**D.1.a.a965 Cowichan Street: Development Permit with Variances
Application No. 00253 (Gonzales)**

Subject: **Development Permit with Variances Application No. 00253 for 965 Cowichan Street**

READ RESIDENCE - GARDEN SUITE

Sheet Title
SITE PLAN

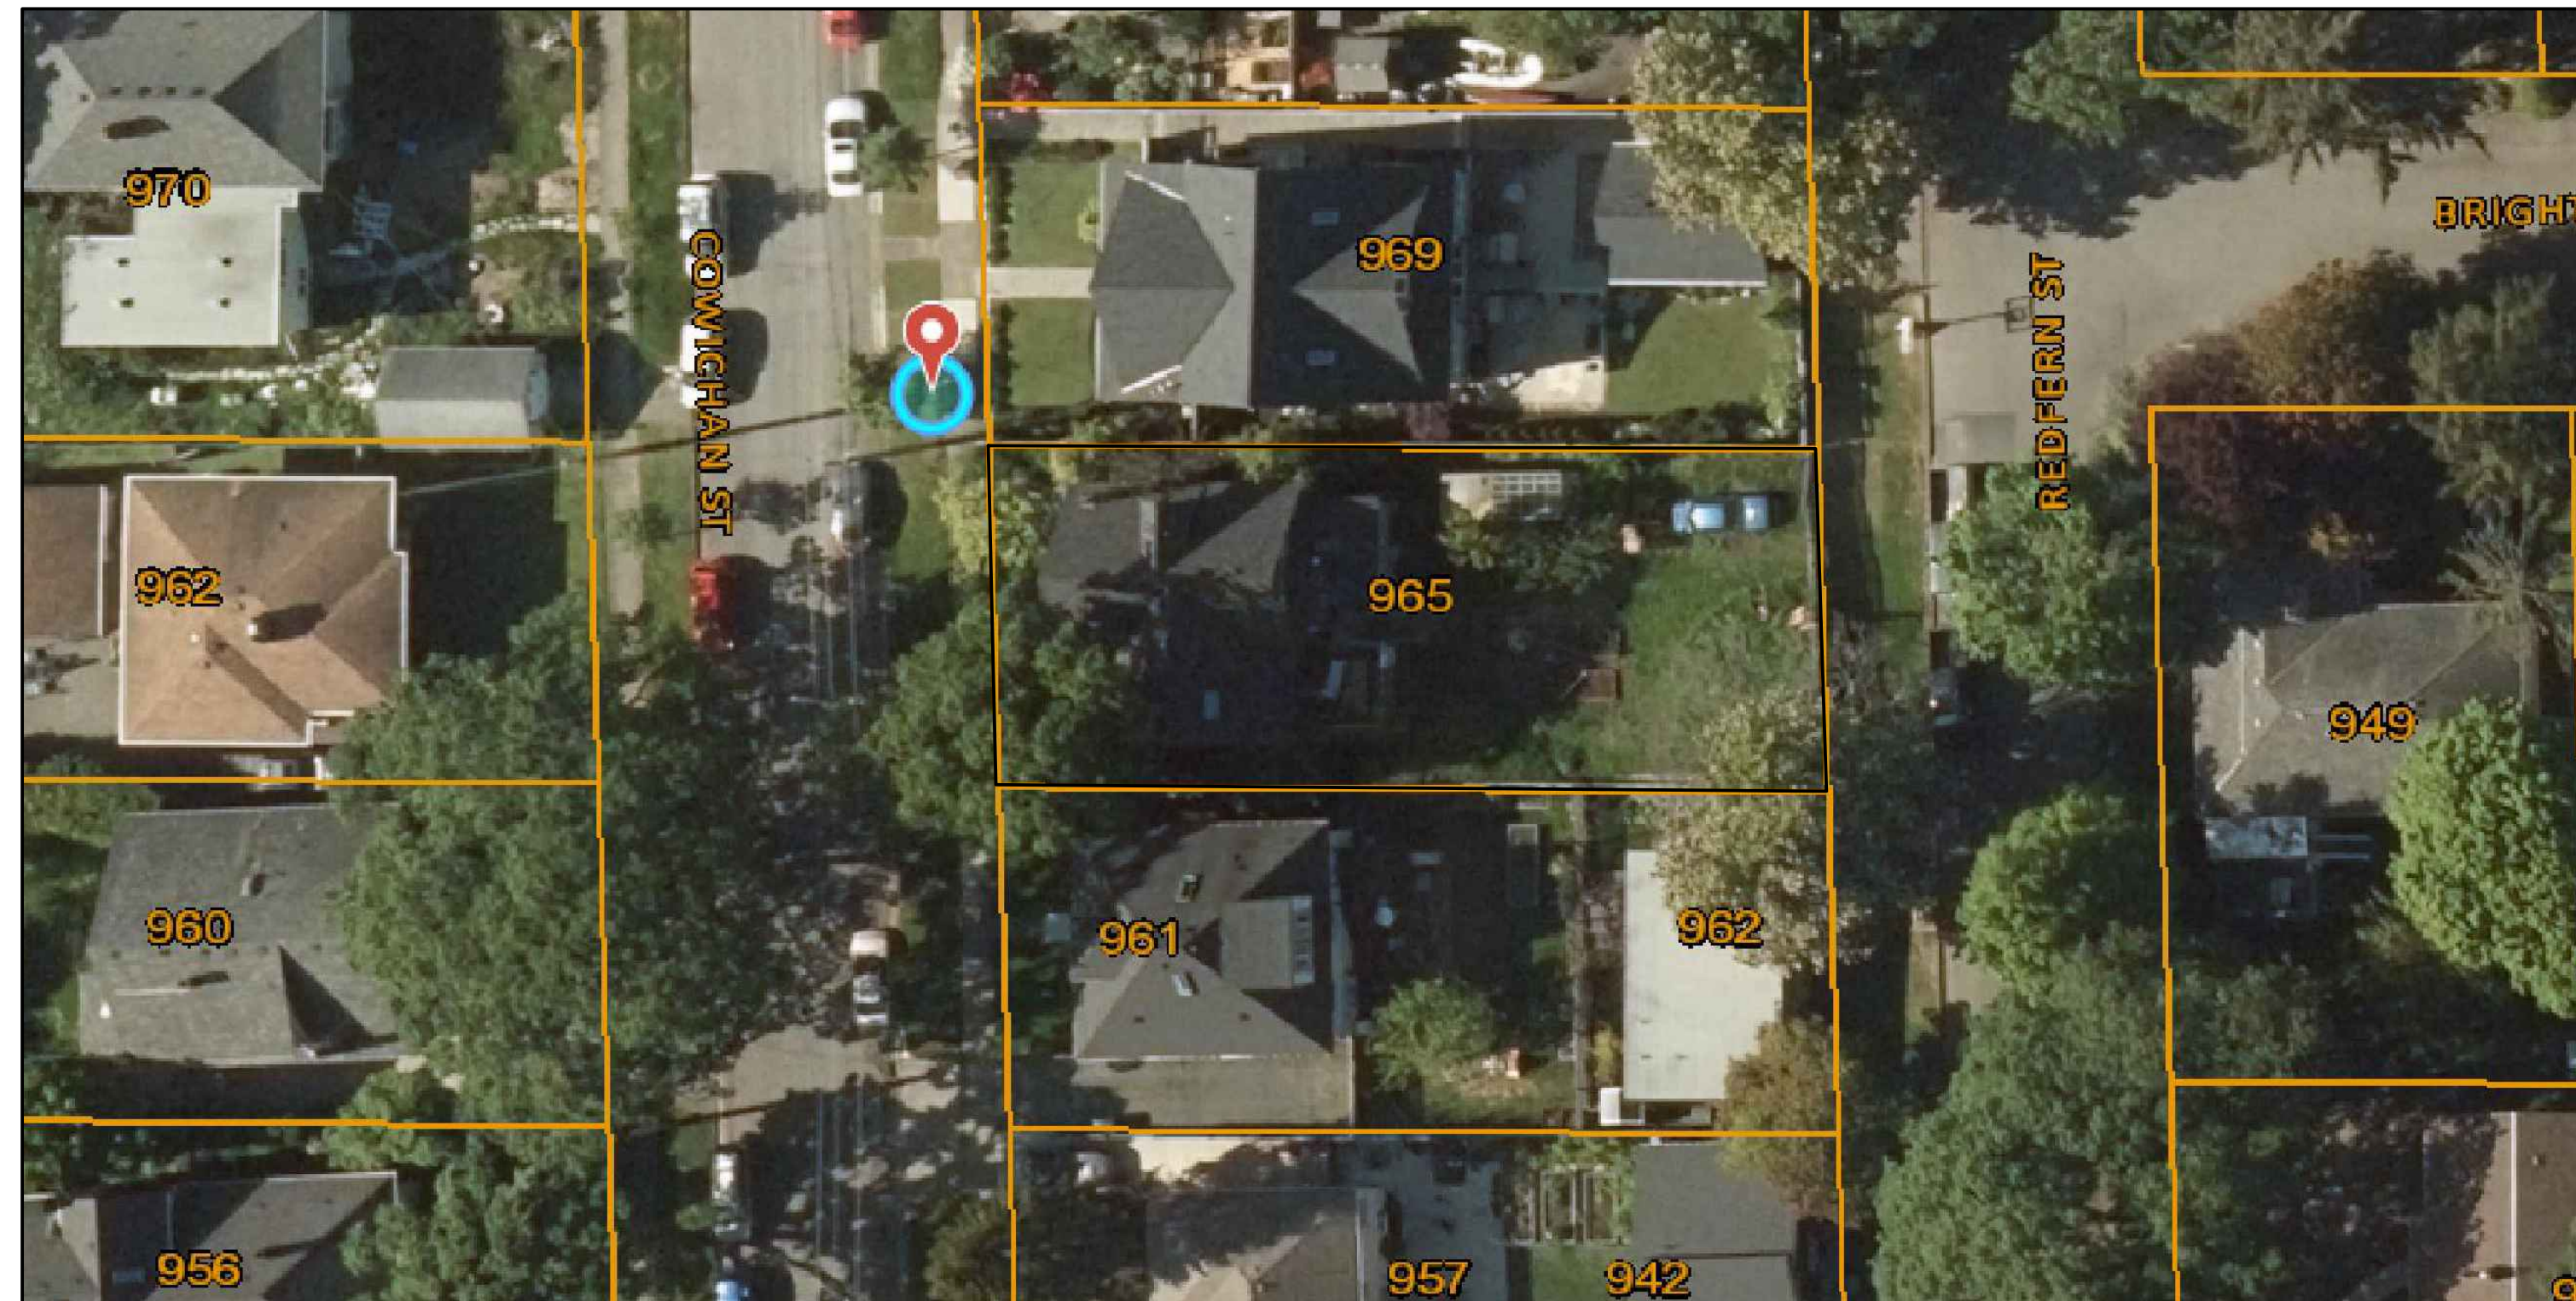
The proposed garden suite is not directly oriented to Redfern Street. There is a carport proposed in between the garden suite and Redfern Street and a fence along the lot line; therefore, there is no orientation or connection to Redfern Street. The applicant has revised the site plan to include a gate and path connecting Redfern Street. The revision in the view of the applicant meets the intent of the guidelines to have some orientation to Redfern Street.

In summary, in order to bring the proposed garden suite into compliance with the design guidelines it is recommended that the applicant revise the site plans to directly orient the garden suite to Redfern Street. Should Council wish to proceed with approving the application as proposed by the applicant, an alternate motion is provided.

1. increase of the maximum site coverage of the lot from 30% to 43%
2. increase of the maximum rear yard site coverage from 25% to 37%.

REVISION NUMBER	COMMENTS (REVISIONS ON A1.1 SITE PLAN UNLESS NOTED OTHERWISE)
1	SITE COVERAGE RECALCULATED, VARIANCE REQUIRED.
2	OPEN SITE SPACE CALCULATED PER SCHEDULE A
3	PARKING SPACE LOCATED AND DIMENSIONED PER SCHEDULE C
4	DRIVEWAY PARKING SLOPE DENOTED. DRIVEWAY CROSSING/ SITE TRIANGLES PER SCHEDULE C
5	DRIVEWAY/PARKING MATERIAL PROVIDED
6	AVERAGE GRADE PROPOSED
7	HEIGHT OF BUILDING DIMENSIONED TO FINISHED GRADE (SEE A3.1)
8	REAR SETBACK DIMENSIONED TO POST
9	REAR YARD SITE COVERAGE CALCULATED PER PLAN CHECK COMMENT
10	LOCATION OF GARBAGE/RECYCLING AREA, NO ENCLOSURE REQUIRED
11	POTTED PLANTS DELINEATE GARDEN SUITE USE OF OUTDOOR SPACE, MORE THAN 15m ² MINIMUM (SEE L1.1)
12	EXISTING SITE SERVICES ARE LOCATED ON SITE PLAN. GARDEN SUITE SERVICES WILL BE CONNECTED TO EXISTING. UPGRADE AND RELOCATION (SEWER LINE) AS REQUIRED
13	STORMWATER MANAGEMENT: MEASURES INCORPORATED TO MANAGE STORMWATER RUNOFF VIA INTERLOCKING PERMEABLE PAVERS IN THE DRIVING AISLE, RAIN COLLECTION BARRELS AT RAINWATER LEADER LOCATIONS IN ADDITION TO PERIMETER DRAIN AROUND THE BUILDING FOR OVERFLOWS, TREES / VEGETATIONS PLANTED TO HELP WITH RUNOFFS.

Our proposal has been revised in order to increase street presence on Redfern. In addition to the sliding gate on the south end of the property line along Redfern we have added just a few feet to the north the inclusion of a smaller pedestrian-sized gate for easy access to the front door of the suite. This gate will have an address sign and mailbox directly facing Redfern. We would also like to include a permeable paver pathway from the road across the boulevard. This area would be landscaped appropriately and include a small light to illuminate the address sign when required. I feel that this should bring our proposal within the design guidelines by clearly indicating that the front door of the property is in fact facing Redfern.
